ADDENDUM NO. 1

Date: May 20, 2022

Project: **Project #0104-416**

Elder Creek ES Playfield Renovation

DEMOLITION PLAN

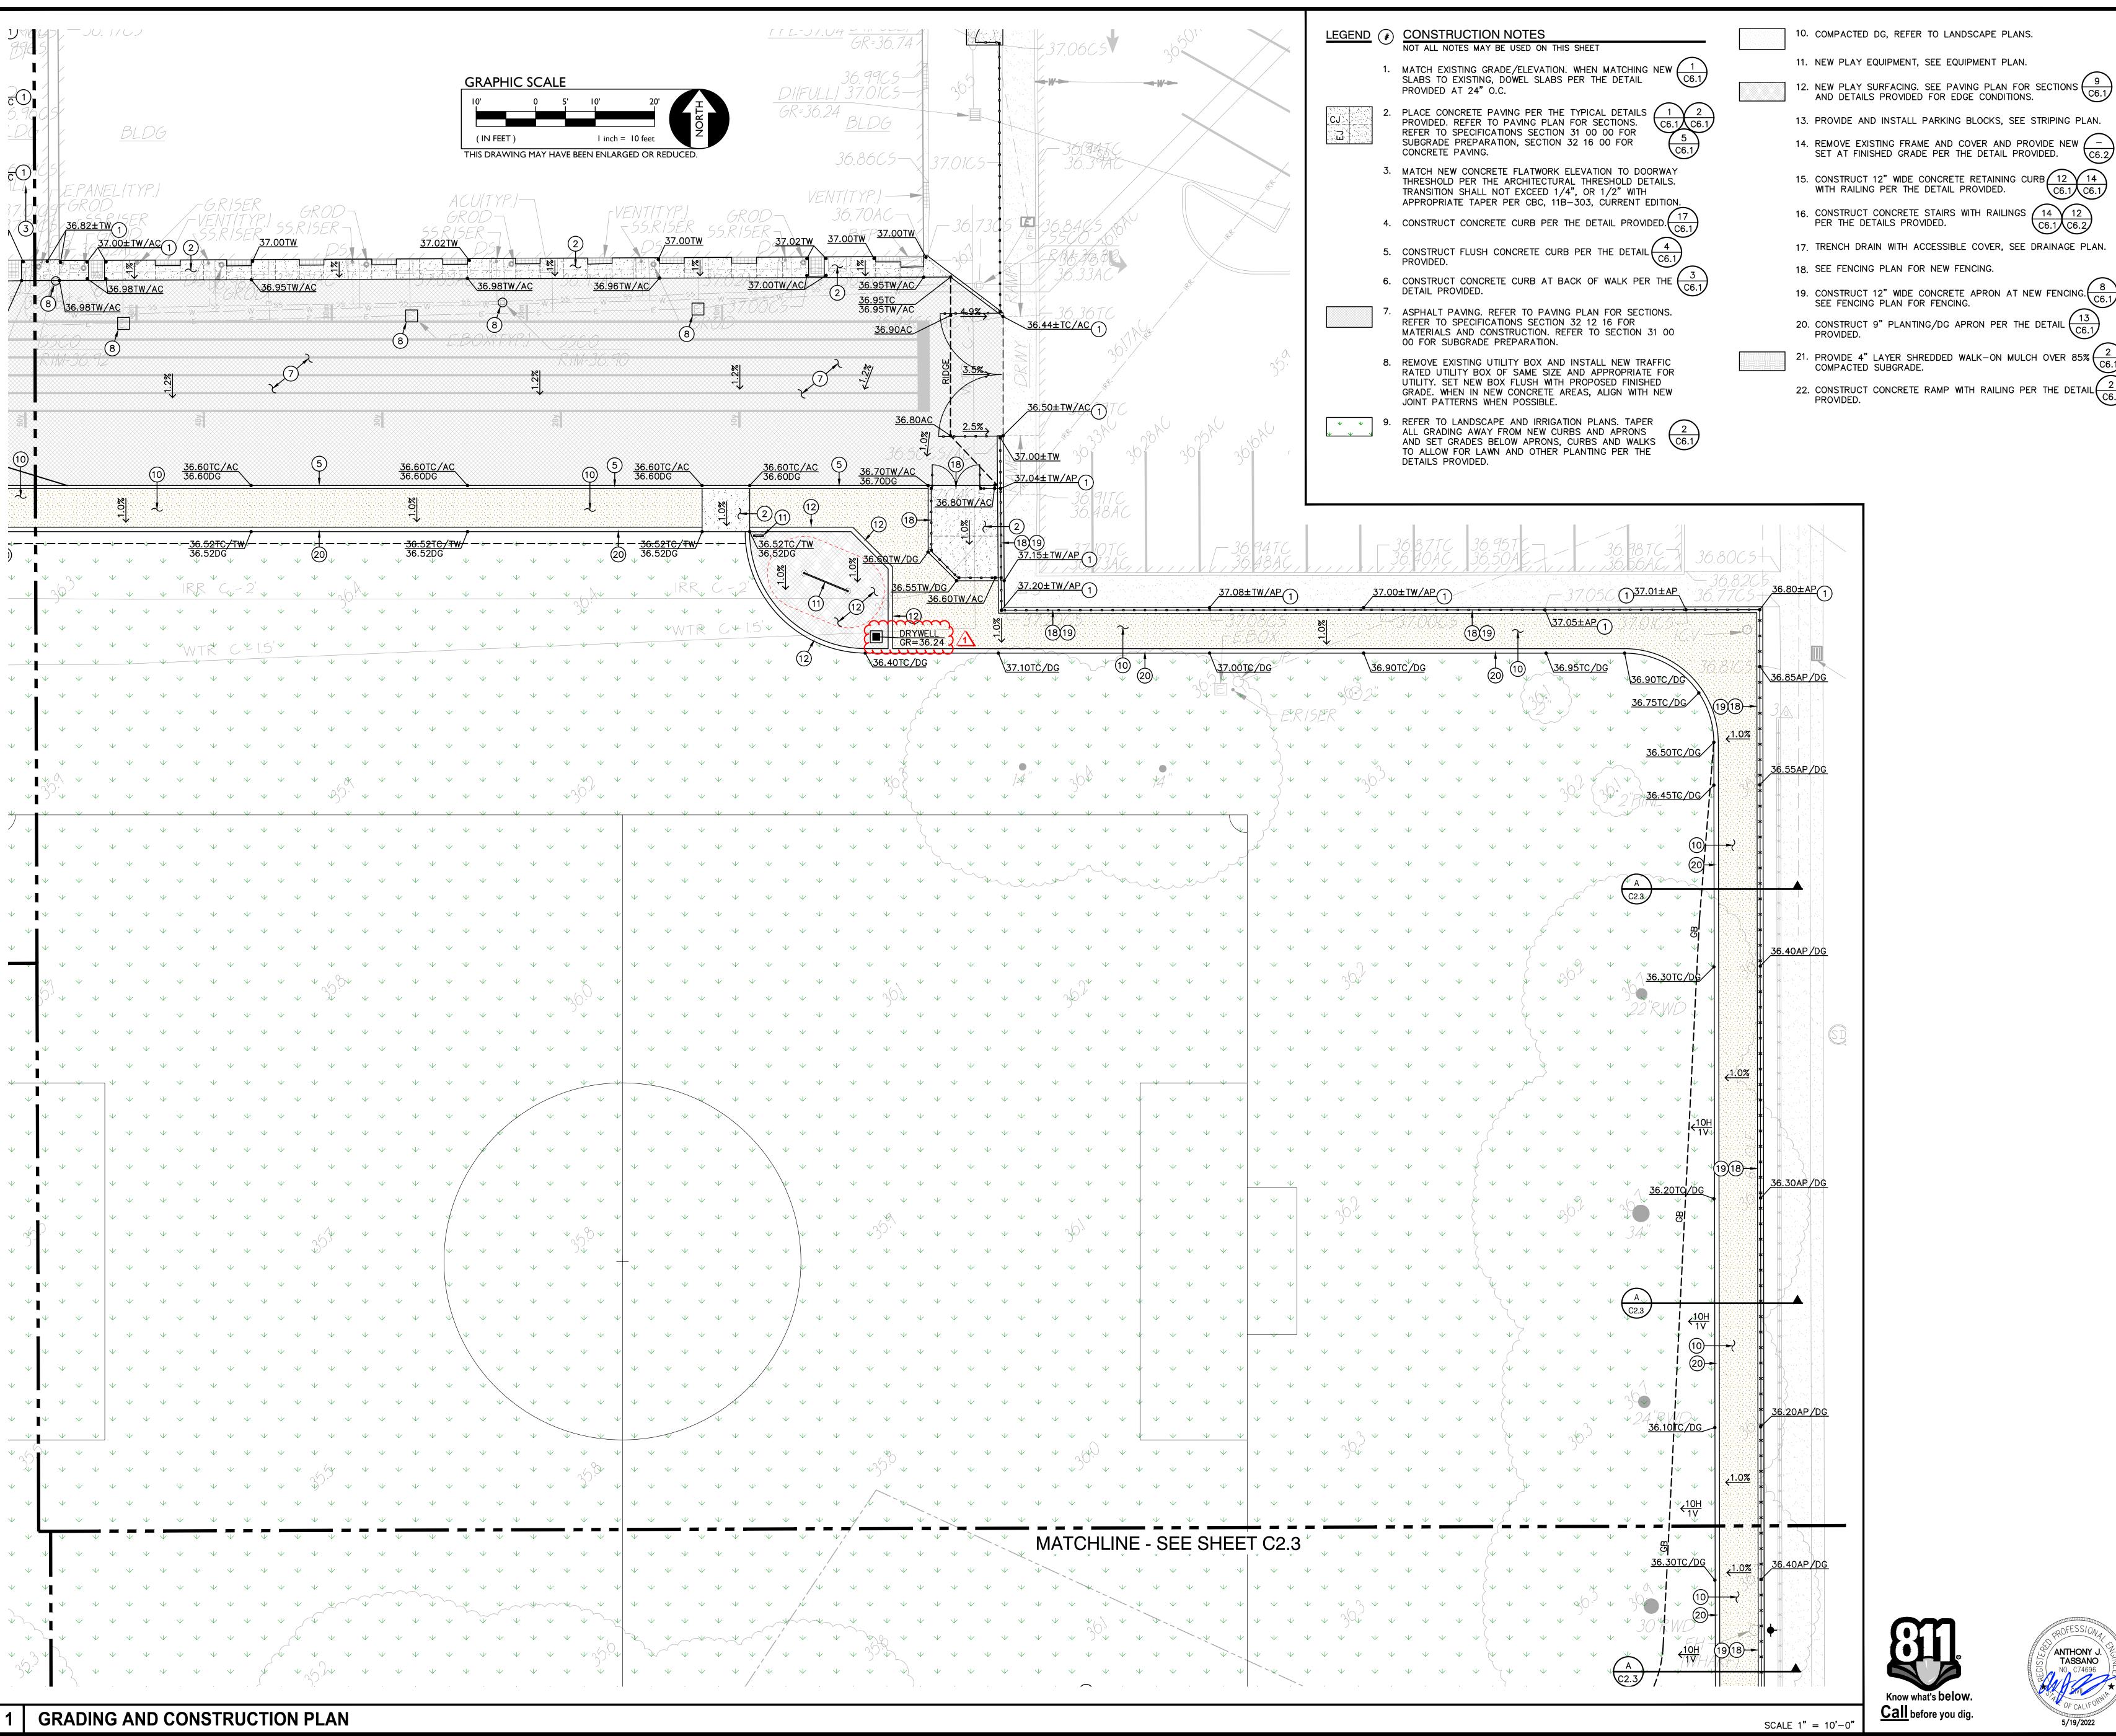
AD1.01 - (Ref) Sheet C1.1: This plan sheet is updated as follows:

Demolition plan updated to coordinate with trees shown for demolition in the landscape drawings.
 trees south of the existing play apparatus are now shown for removal on C1.1 to match that shown on landscape drawings.

GRADING AND CONSTRUCTION PLAN

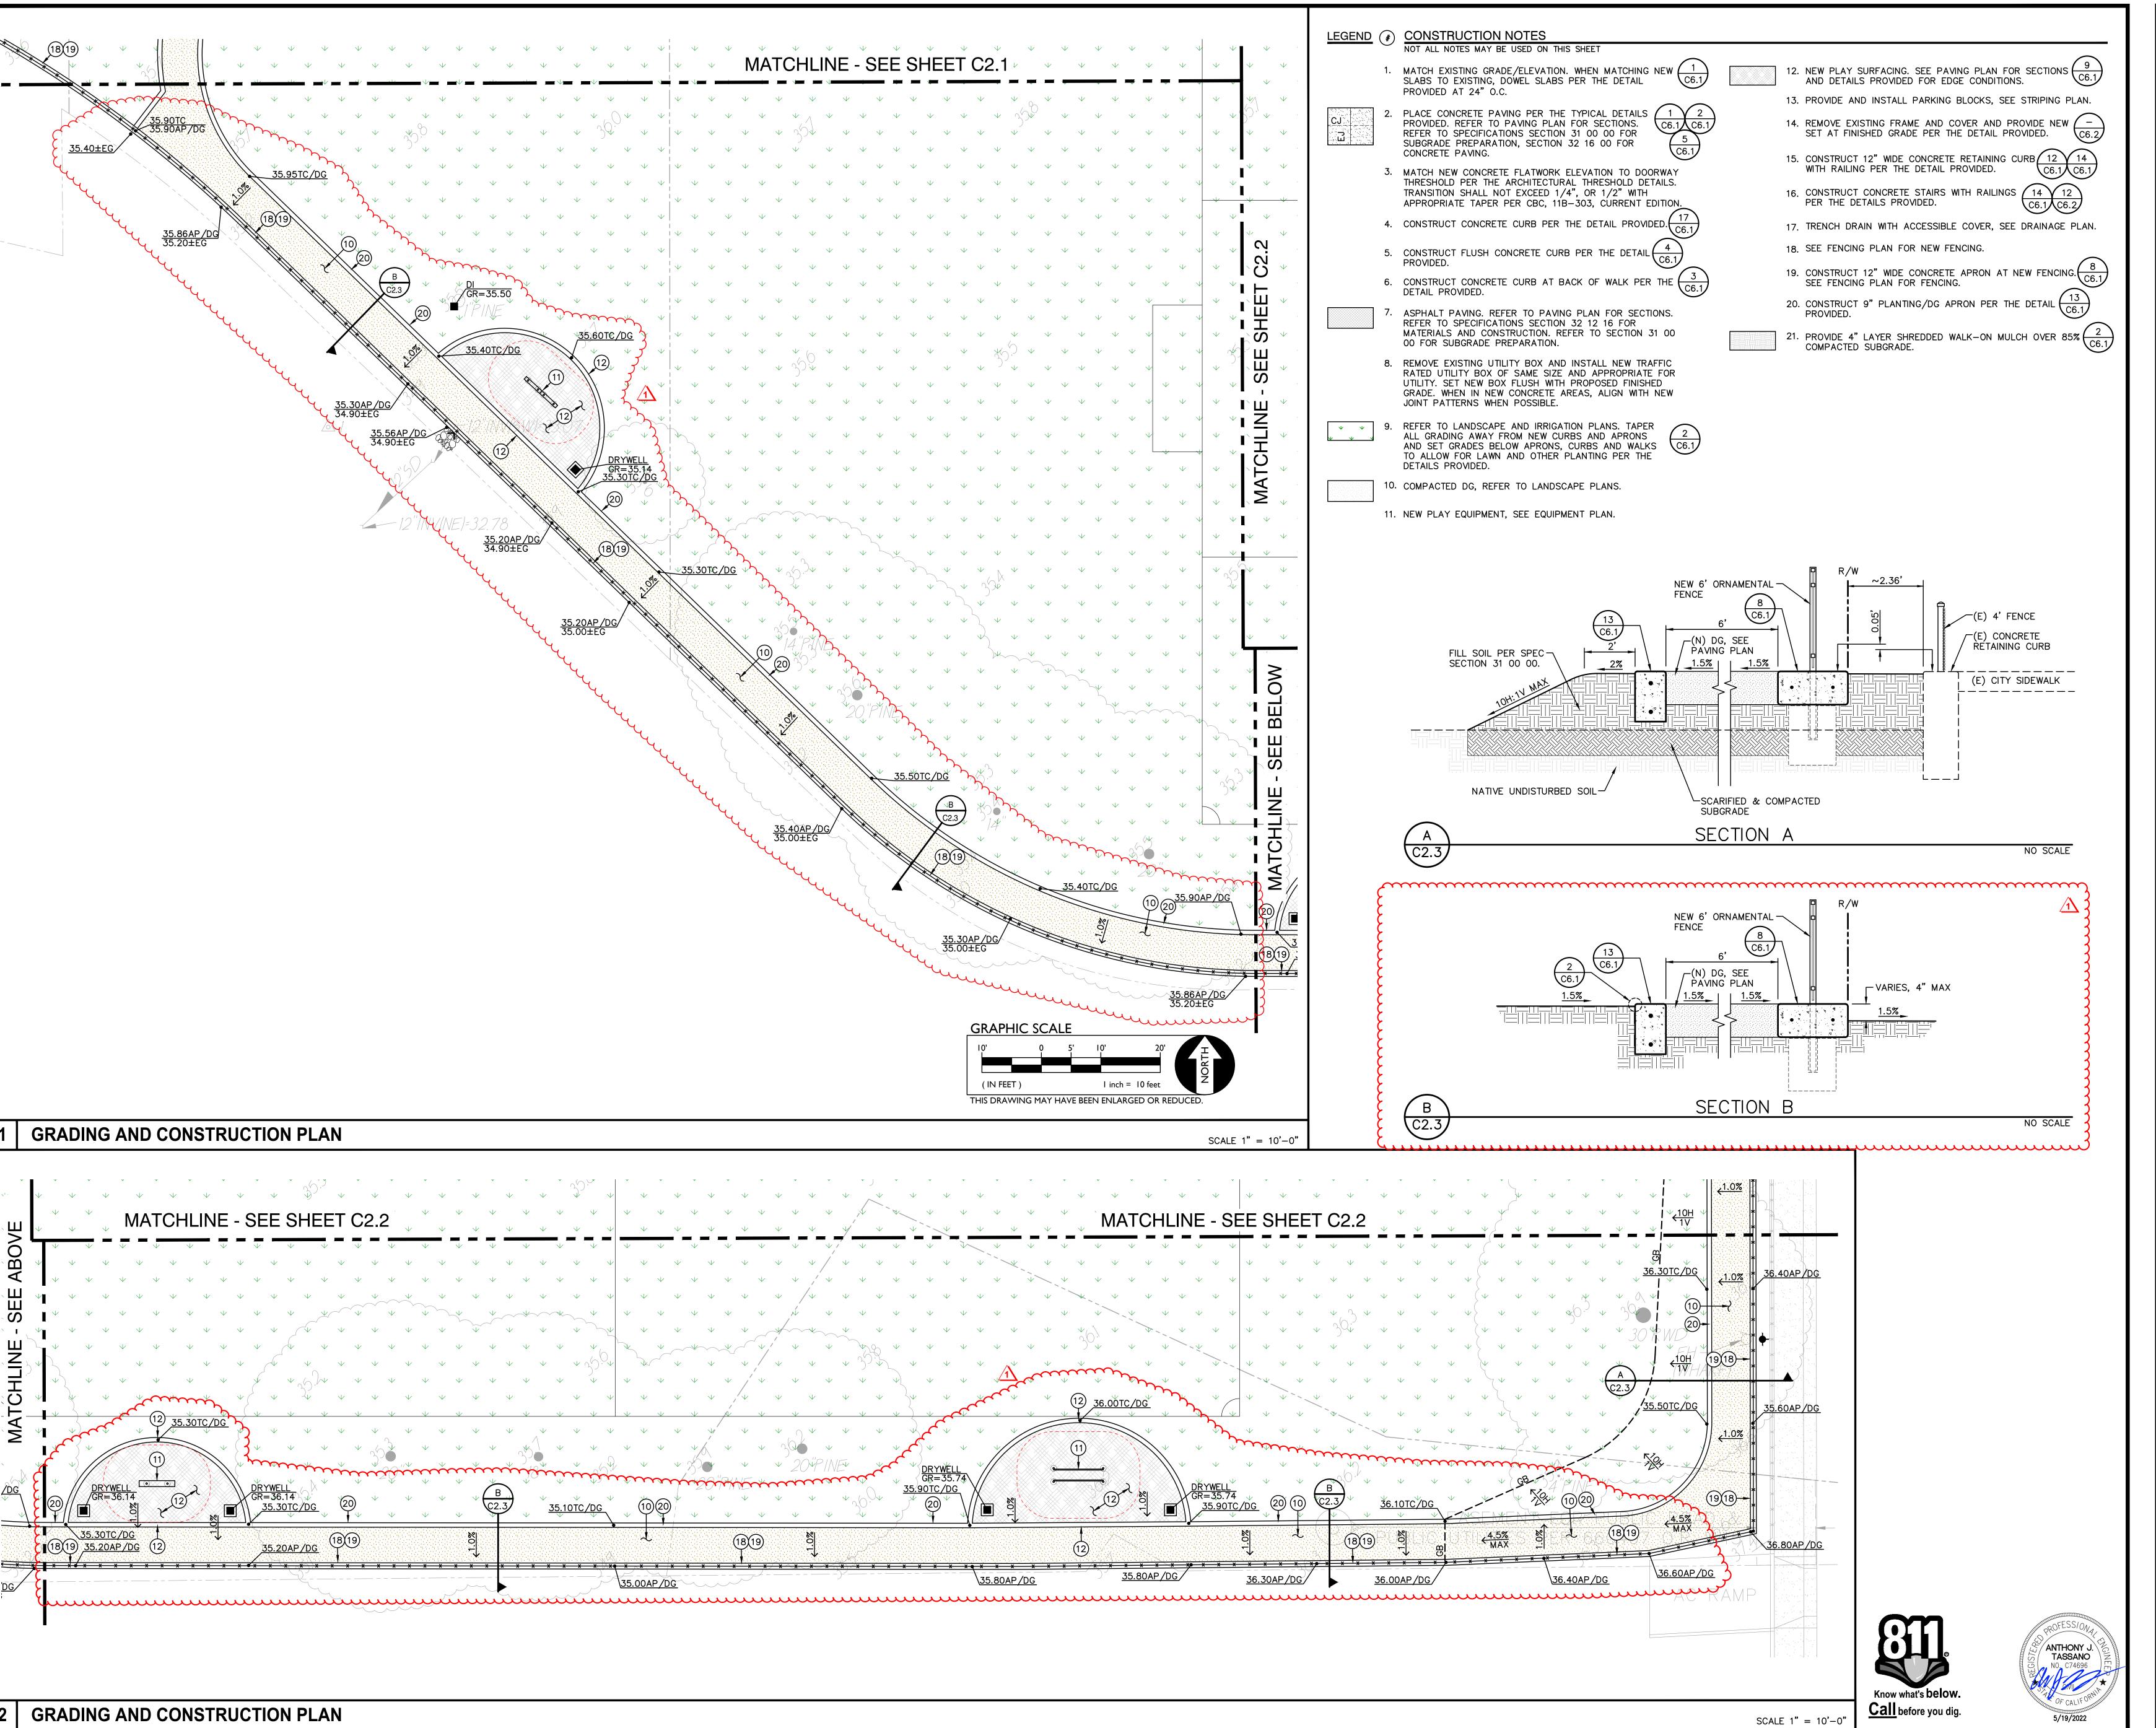
AD1.02 - (Ref) Sheet C2.2: This plan sheet is updated as follows:

1. One (1) Drywell added beneath the play surfacing at the exercise equipment.

AD1.03 - (Ref) Sheet C2.2: This plan sheet is updated as follows

- 1. Additional grade elevations provided at various locations along south walking path along Soth fenceline.
- 2. Drywell added beneath the play surfacing at the exercise equipment.
- 3. Five (5) Drywells added beneath the play surfacing at 3 exercise equipment areas.
- 4. Cross section B/C2.3 added to clarify the grading at the property line.

AD1C3.1

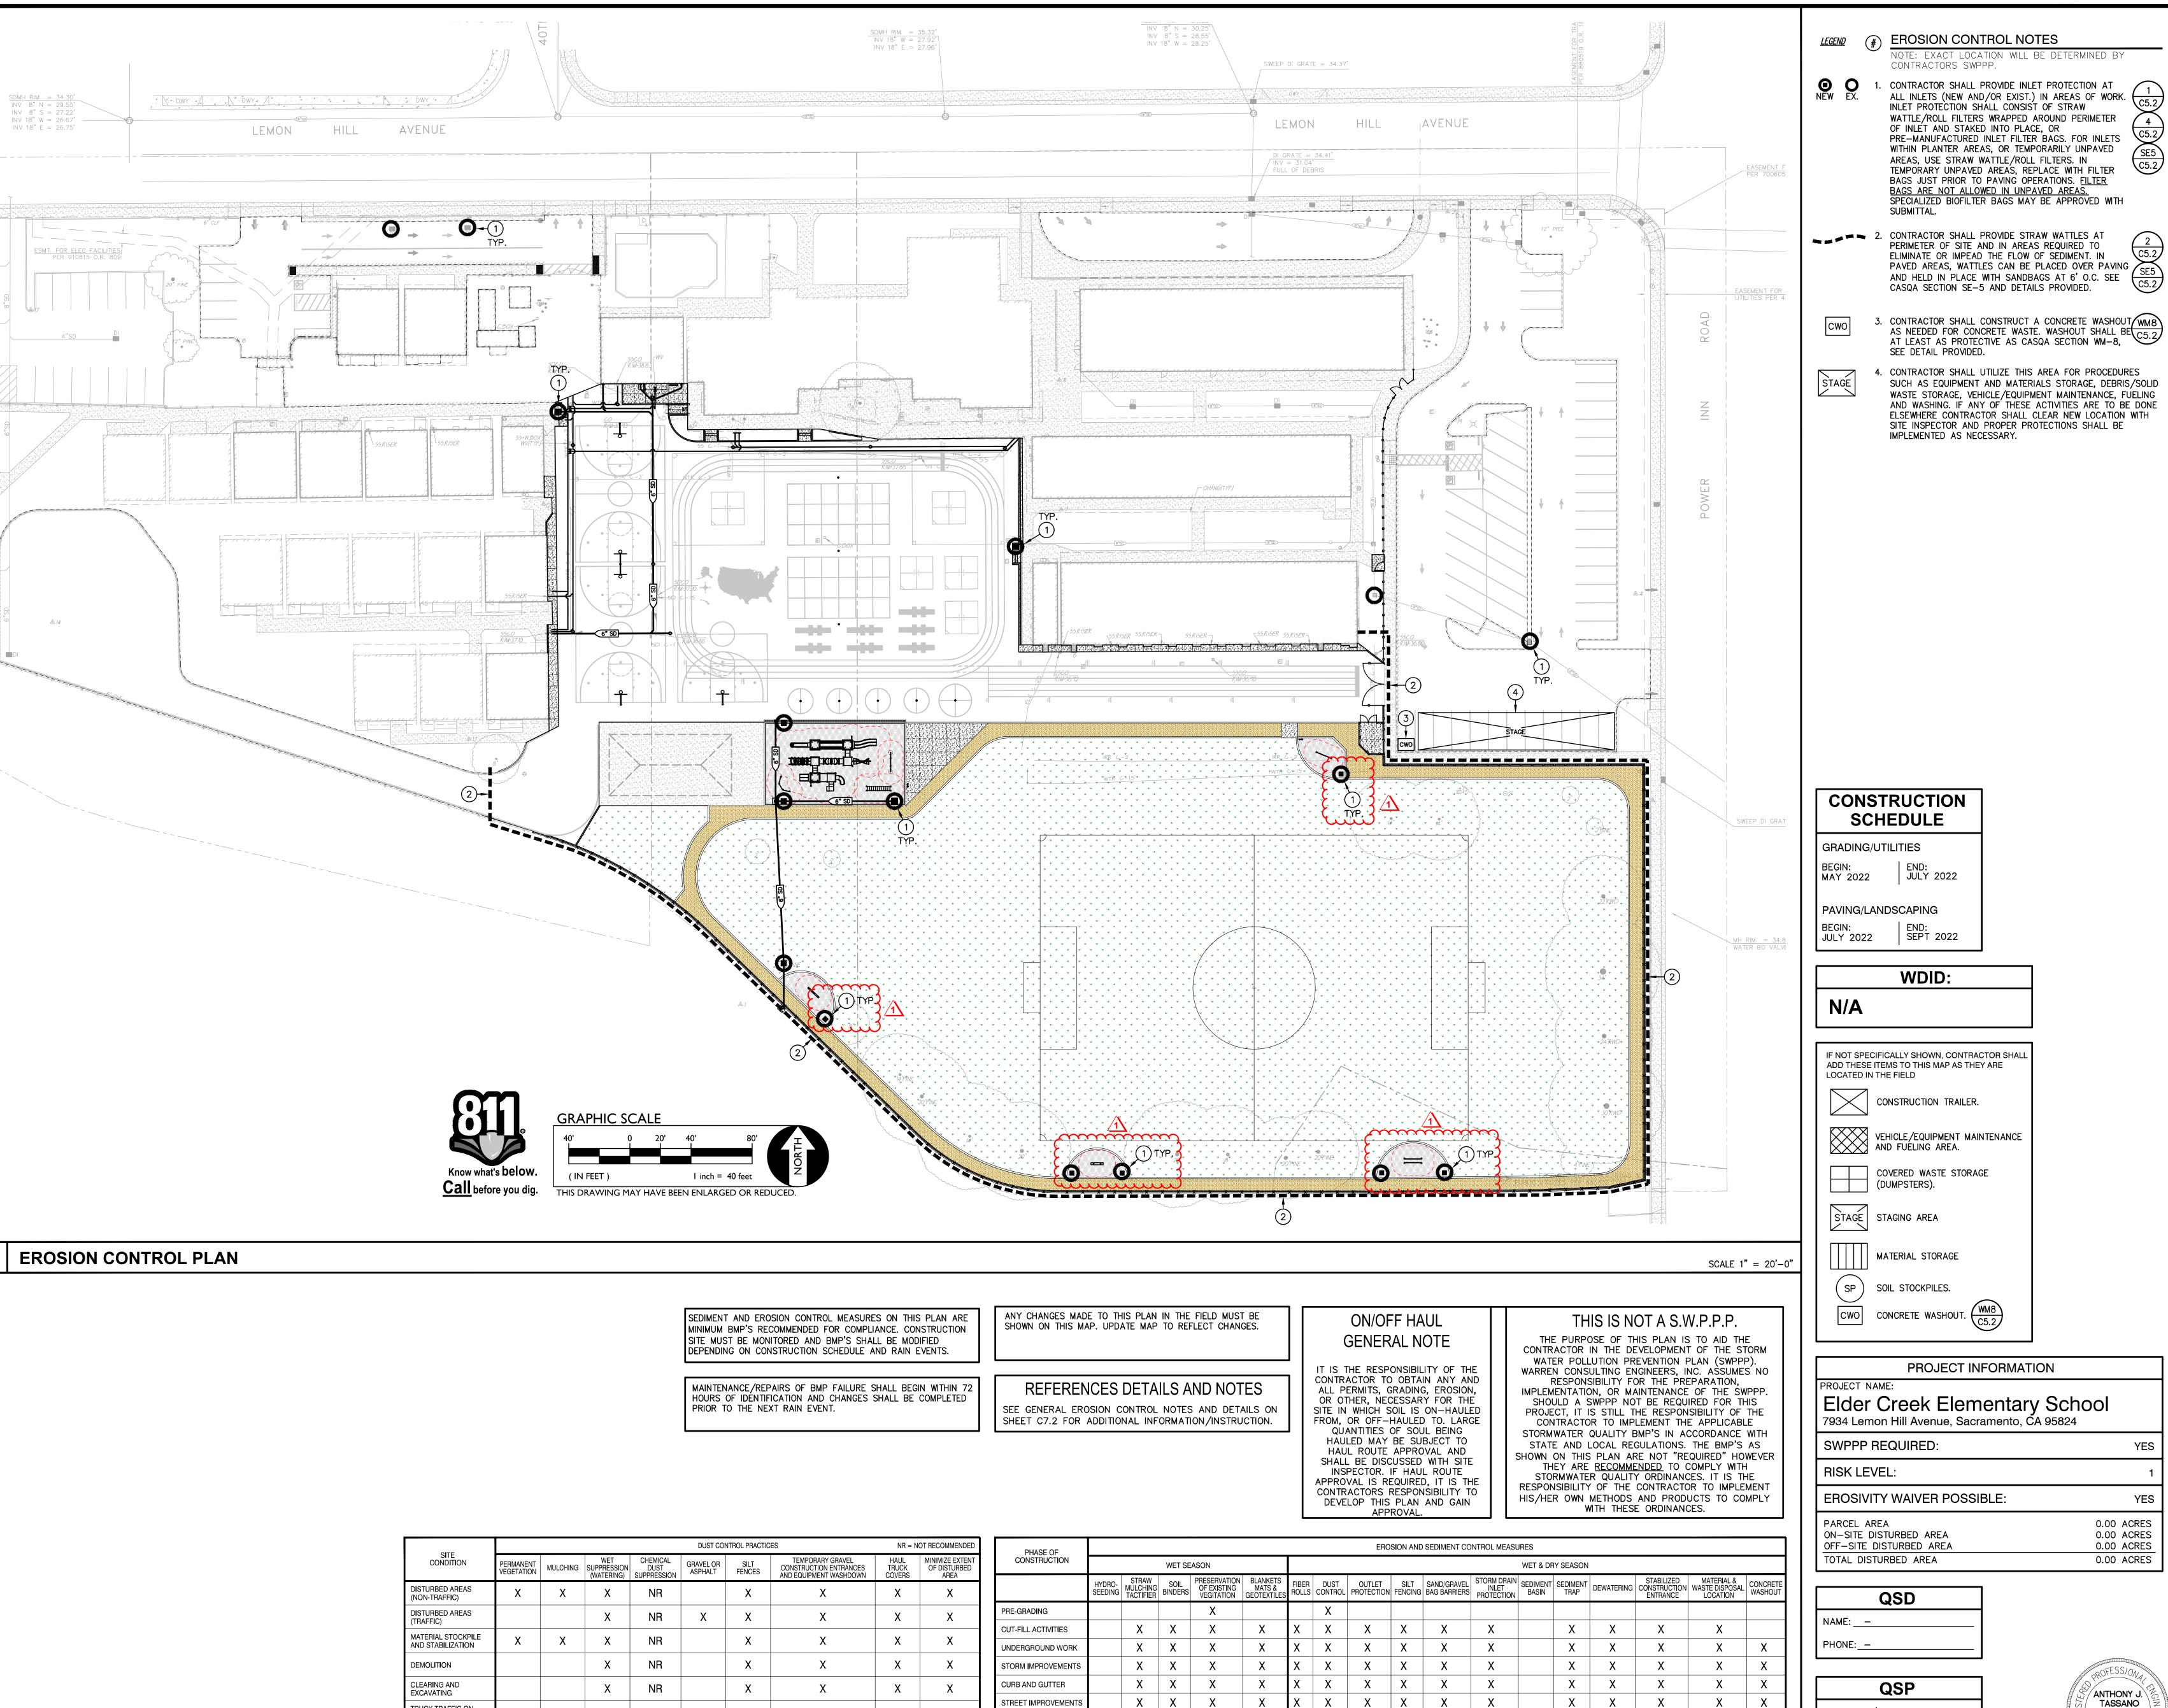
AD1.04 - (Ref) Sheet C3.1: This plan sheet is updated as follows

- 1. Six (6) Drywells added beneath the play surfacing at 4 exercise equipment areas.
- 2. Construction note 43 has been added to reference the drywell detail per item 1 above.

m🟲 43. CONSTRUCT DRYWELL BENEATH PLAY SURFACING PER 🕂 THE DETAILS PROVIDED.
